Re: Zero Canal Plaza Development
Level II Site Plan Application – Response to Comments

On behalf of Cow Plaza 1 LLC, we present the following responses to comments provided by staff and peer reviewers on the project. We have included each of the original questions below in italics.

Engineering Review memo from Stephen Bushey, dated August 1, 2016

C-203

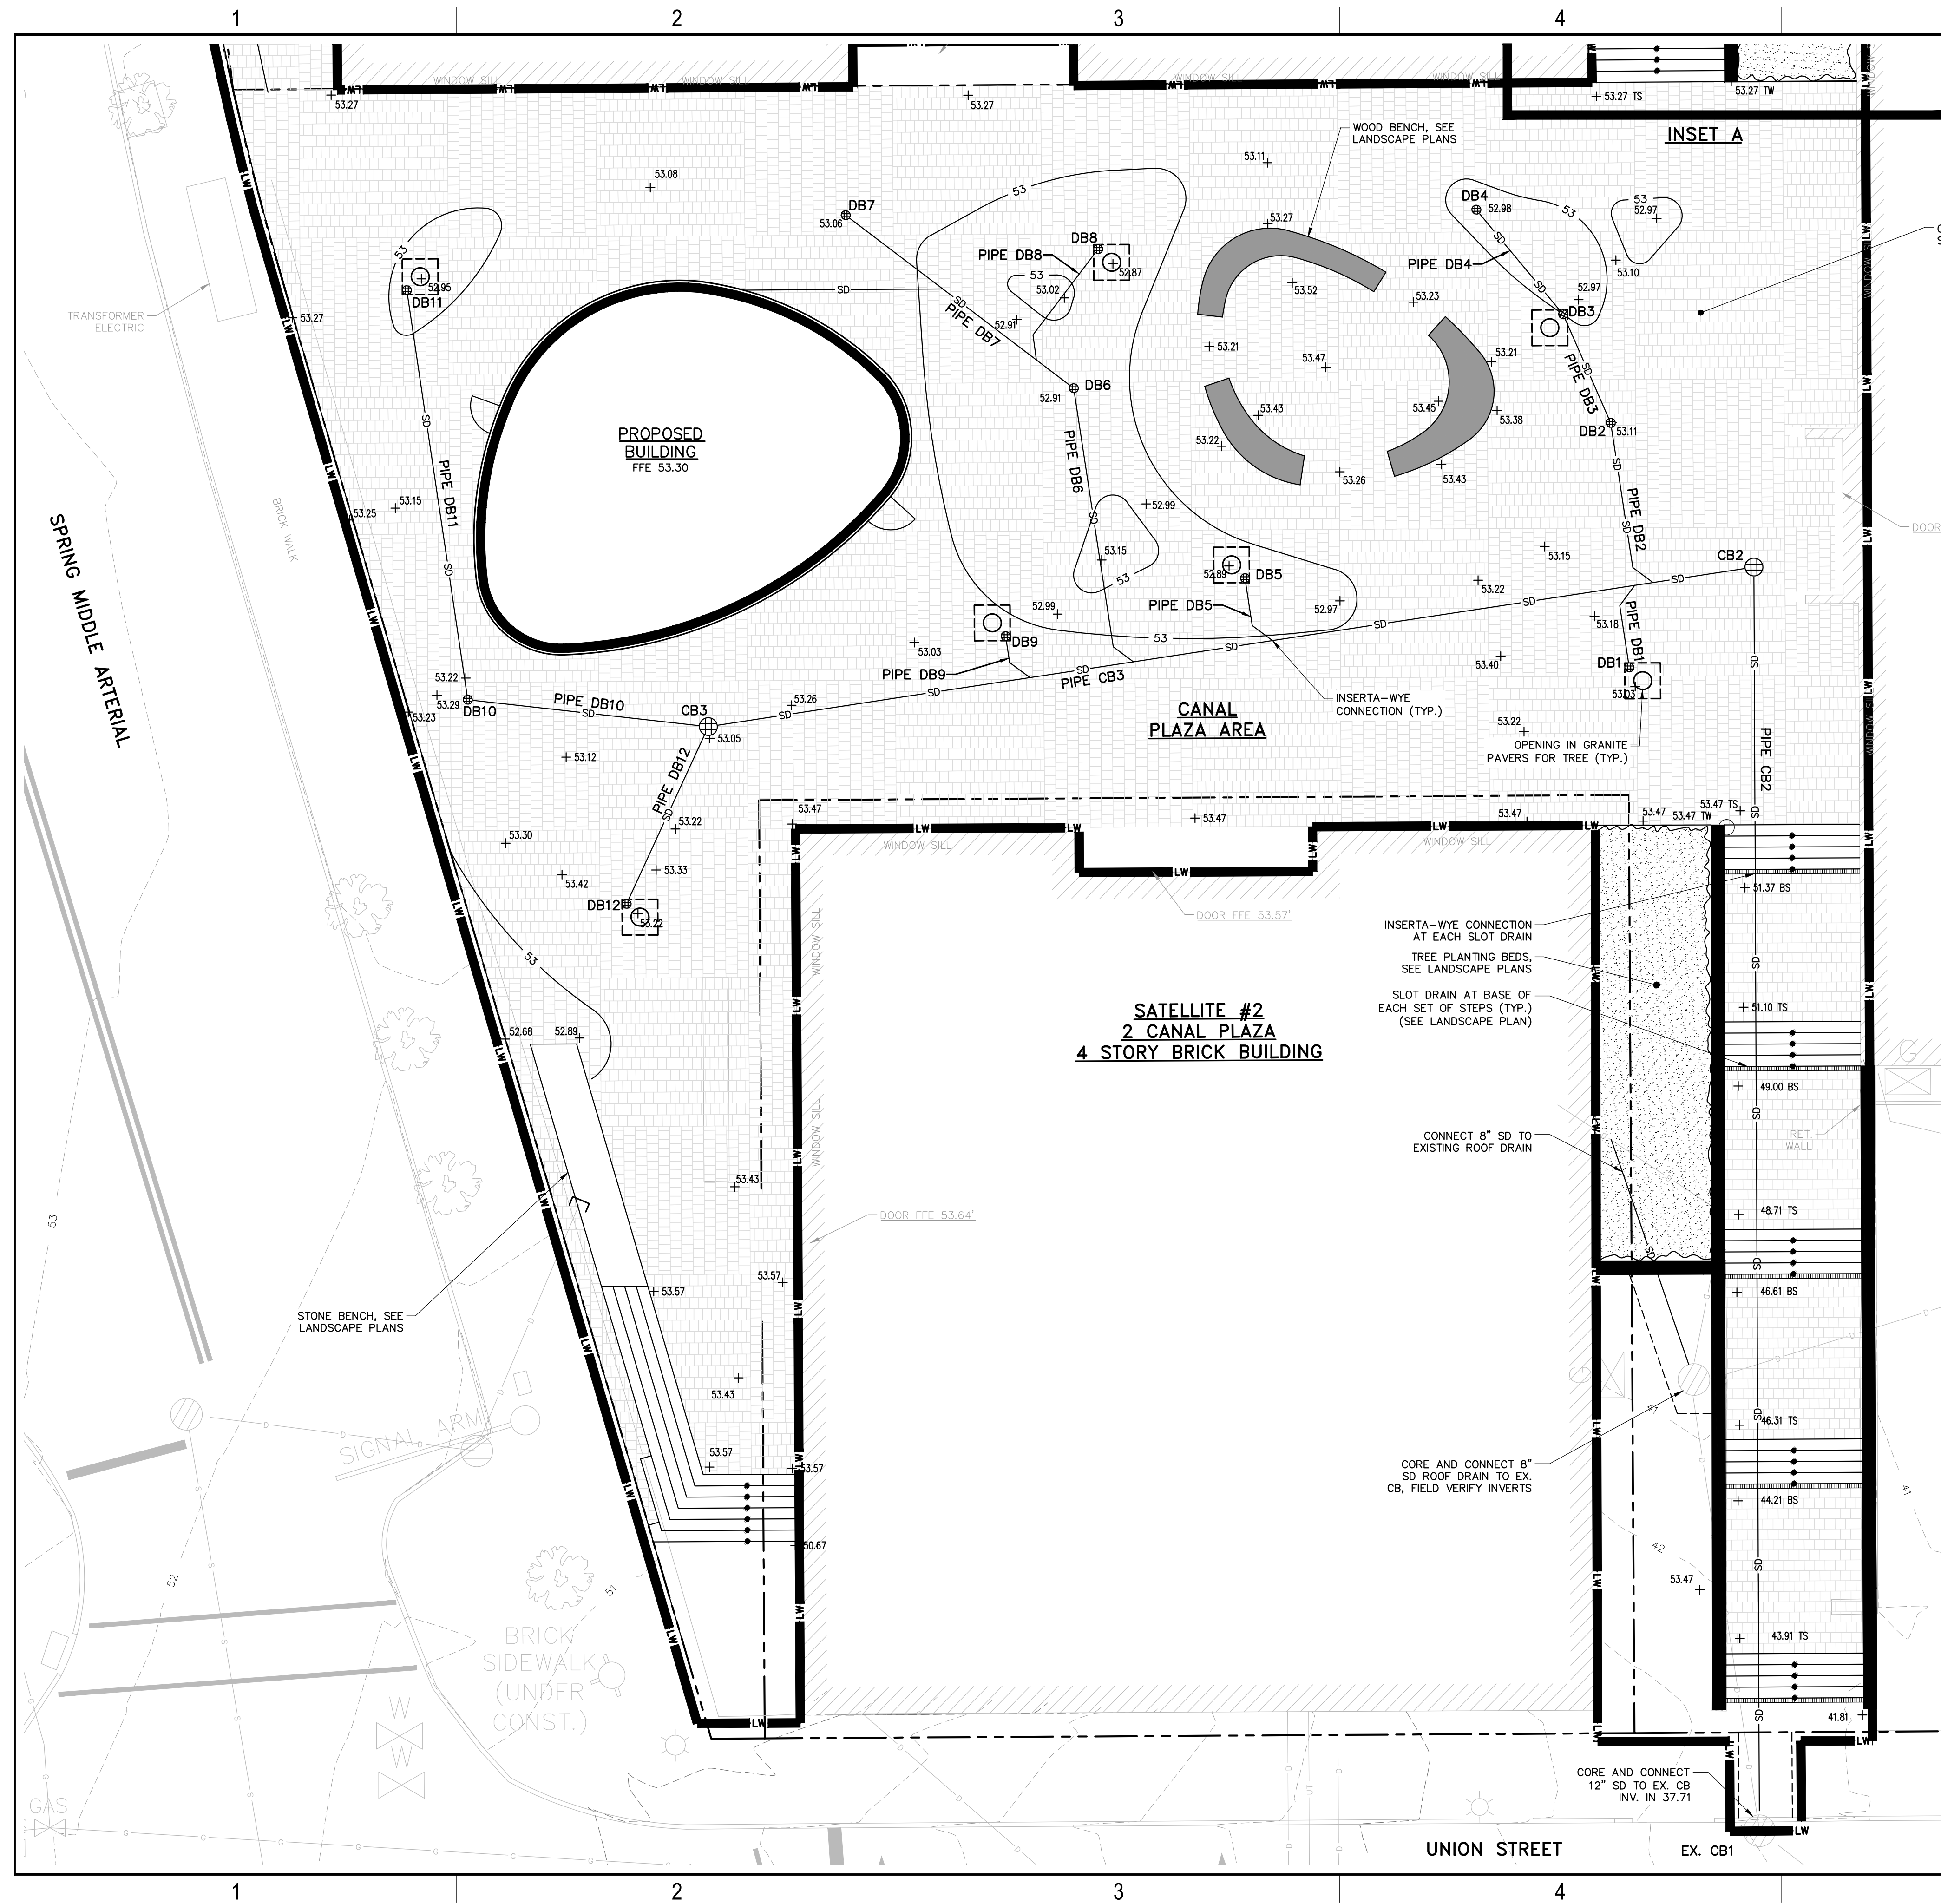
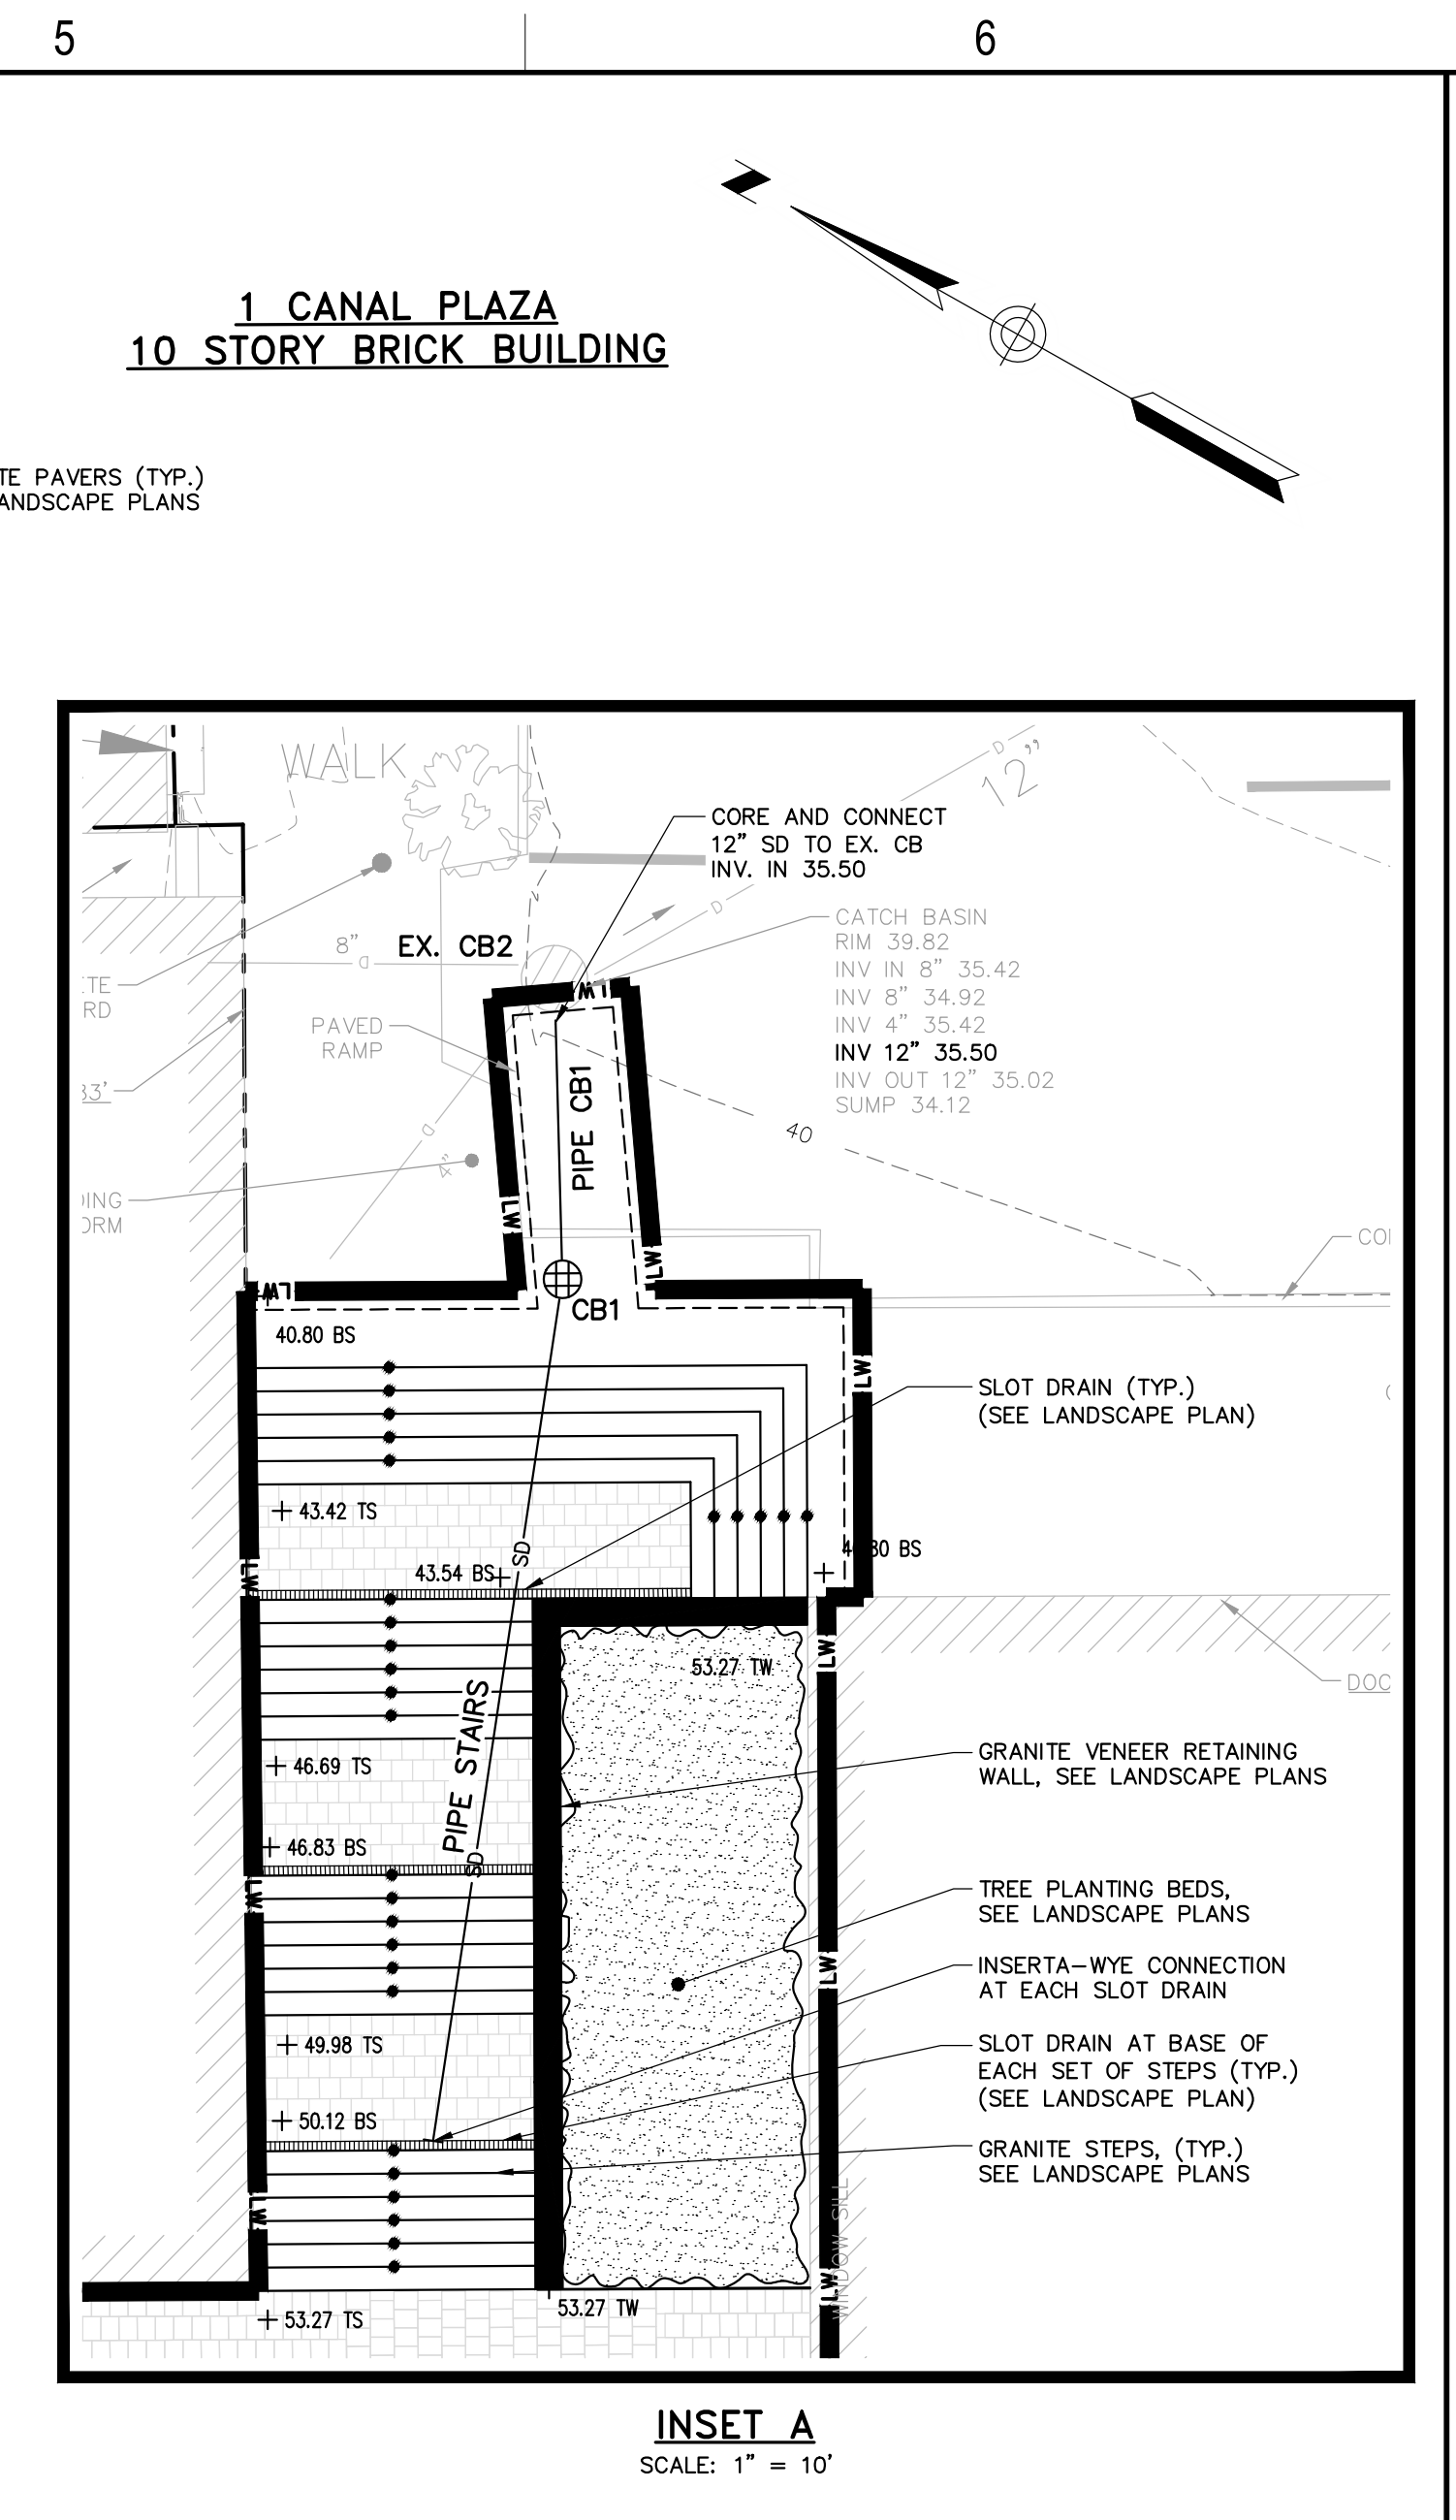
- 1. The structure Table appears to have a couple of inconsistencies. The Rim elev for CB1 seems too low. DB 3 should be added to the table. The rim for Ex CB2 should be 39.82' and that same structure has a number of pipes entering and exiting. The structure size is also unclear.*

- 2. The ex CB1 on Union Street labeling is inconsistent between sheets C-100 and C-202. C203 suggests an invert into the structure at 35.50', however that is lower than the apparent invert out. C-202 likely is correct in indicating an invert out of 37.71'.*

- 3. The work limits may need to be expanded slightly on Union Street given the work to be performed. This includes removing and resetting of curb and concrete sidewalk reconstruction.*

- 4. Will the proposed building in the plaza have any foundation drainage and if so, where will it tie into? Similarly the walls will have foundation drains that will need to tie into pipe or structures.*

- 5. The designer might consider simply changing the proposed CB2 structure to a drain manhole possibly, since it is unlikely to see much water entering into the structure, based on the proposed rim grade. A solid cover in front of an entrance may be more desirable rather than a grated opening.*

6. The designer has used multiple slot drains within the stairs. These should work well. The designer might consider the use of similar slot or trench drains in the plaza area, in place of the 8" drain basins, perhaps for aesthetics and ability to capture water across a wider space. This is only a suggestion and it's understood that costs and other design decisions may preclude this approach.

The structure table has been updated with the correct CB 1 rim elevation, DB 3 information, and appropriate Ex CB2 information.

The note provided on sheet C-203 was an error and has been corrected to be consistent with all other sheets and notations at 37.71.

Union Street is a moratorium street, and the intent is to maintain all impacts below grade and out of the street.

Final foundation drain locations will be shown on the structural drawings. Final coordination of location will take place as part of construction drawing development.

At this time, the intent is for the structure will remain as a catch basin inlet to provide drainage relief near the building as necessary.

Slot drains were considered for the plaza early as part of the design process, but were eliminated in favor of the drain basin alternative.
